**BOARD OF ZONING ADJUSTMENT
STAFF REPORT**

Date: January 9, 2023

6491/6402

PARKING SCREENING: Parking Screening Variance to allow reduced tree plantings for a parking lot in a T-5.1 Sub-District of the Downtown Development District.

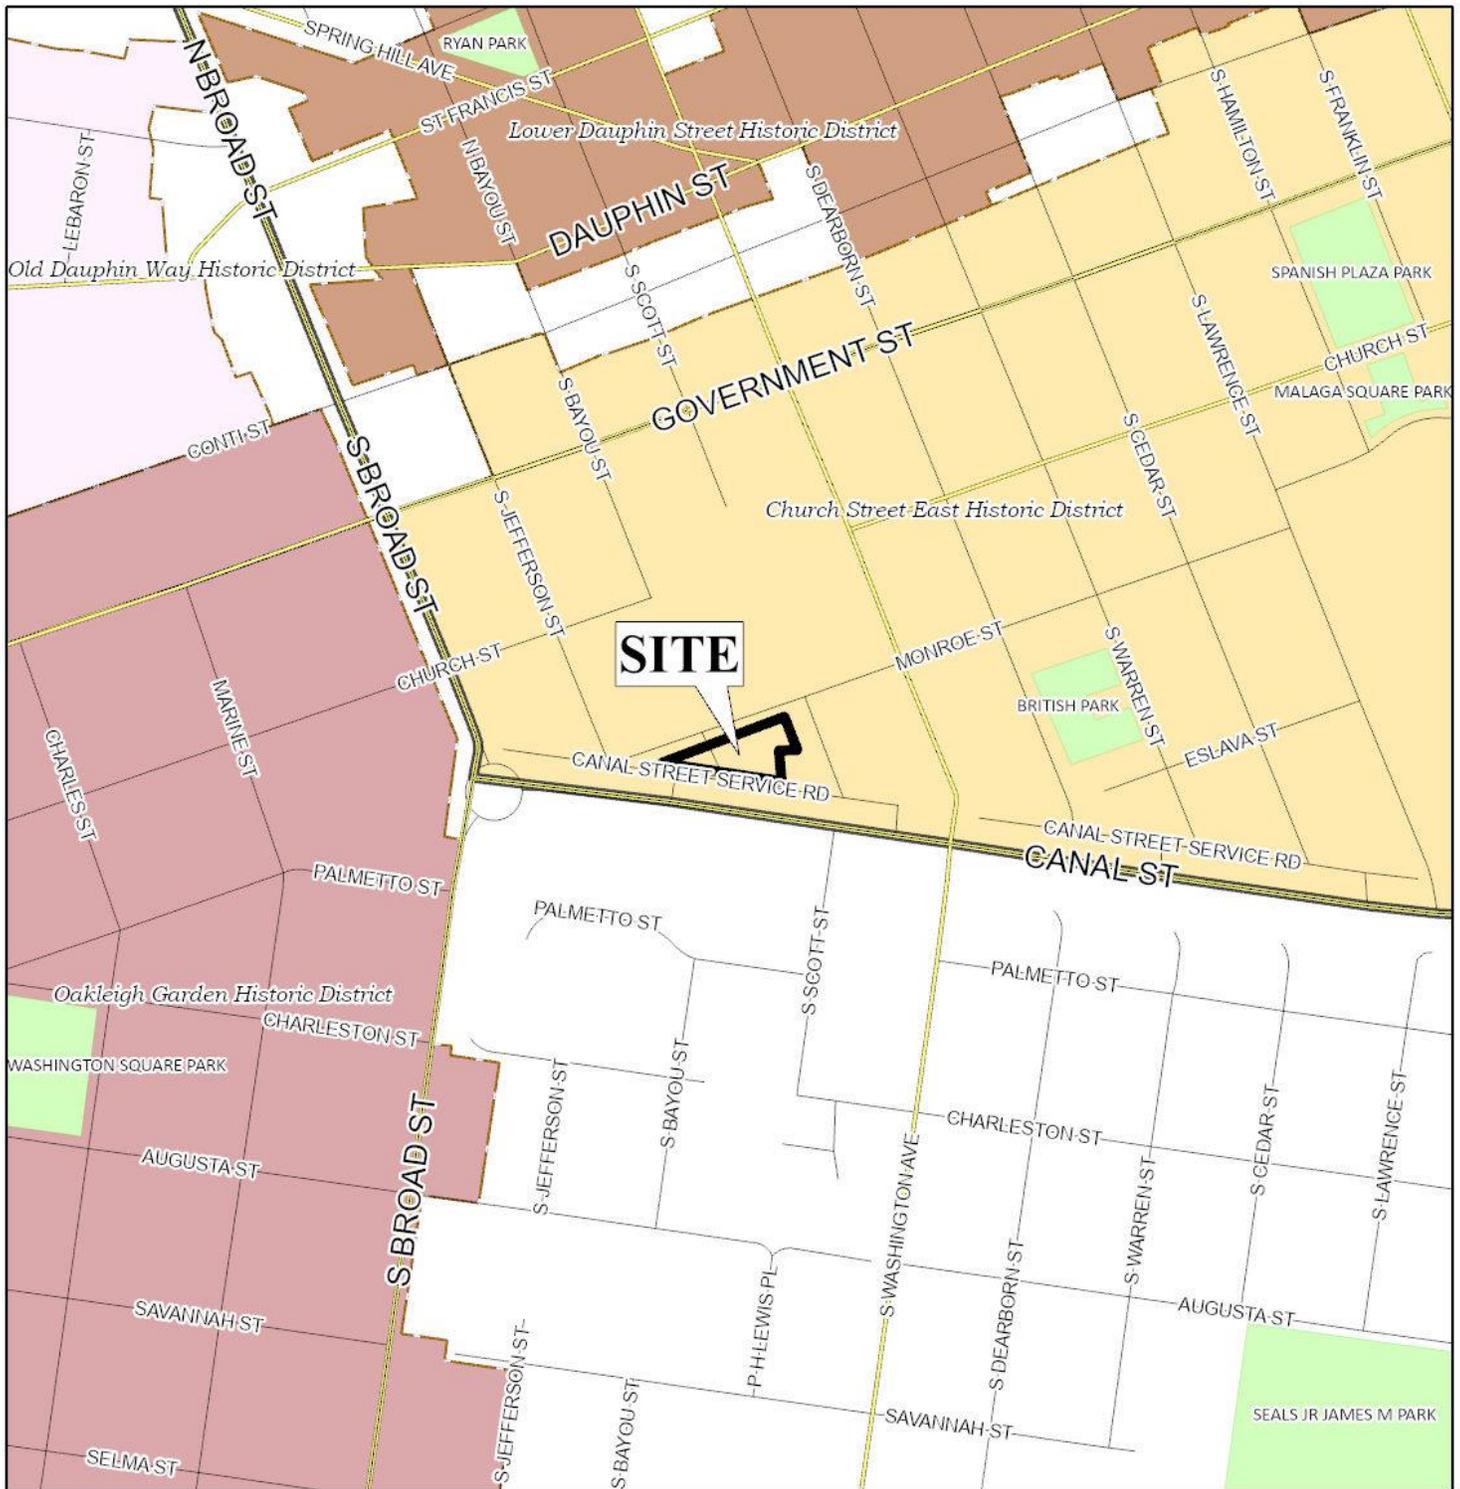
The drawing submitted shows four (4) trees and one (1) monument sign that is proposed to be installed within the Canal Street ROW. If these five (5) items are proposed to be installed in the ROW, then a ROW Permit will be required prior to installation. In addition, the newly installed monument sign in the Canal St ROW has received a Sign Permit; however, it is not allowed to be constructed within the ROW. It will have to be removed; or, the applicant will need to submit a request for a ROW Permit and a Non-Utility Use Agreement.

However, the site plan submitted indicates that the existing monument sign and proposed tree plantings are within the Canal Street public right-of-way, and not on the subject site. A sign permit was approved in 2020 for the monument sign to be installed on the subject site and not within the right-of-way. The proposed tree plantings must also be on the subject site and not within the right-of-way.

RECOMMENDATION: Due to the fact that the site plan indicates the existing monument sign and proposed tree plantings to be within the Canal Street public right-of-way, this application is recommended for holdover to the March 6th meeting to allow the applicant to relocate the monument sign onto the subject site and revise the site plan to indicate the proposed tree plantings will be on the subject site, or begin the process to request a ROW Permit and a Non-Utility Use Agreement.
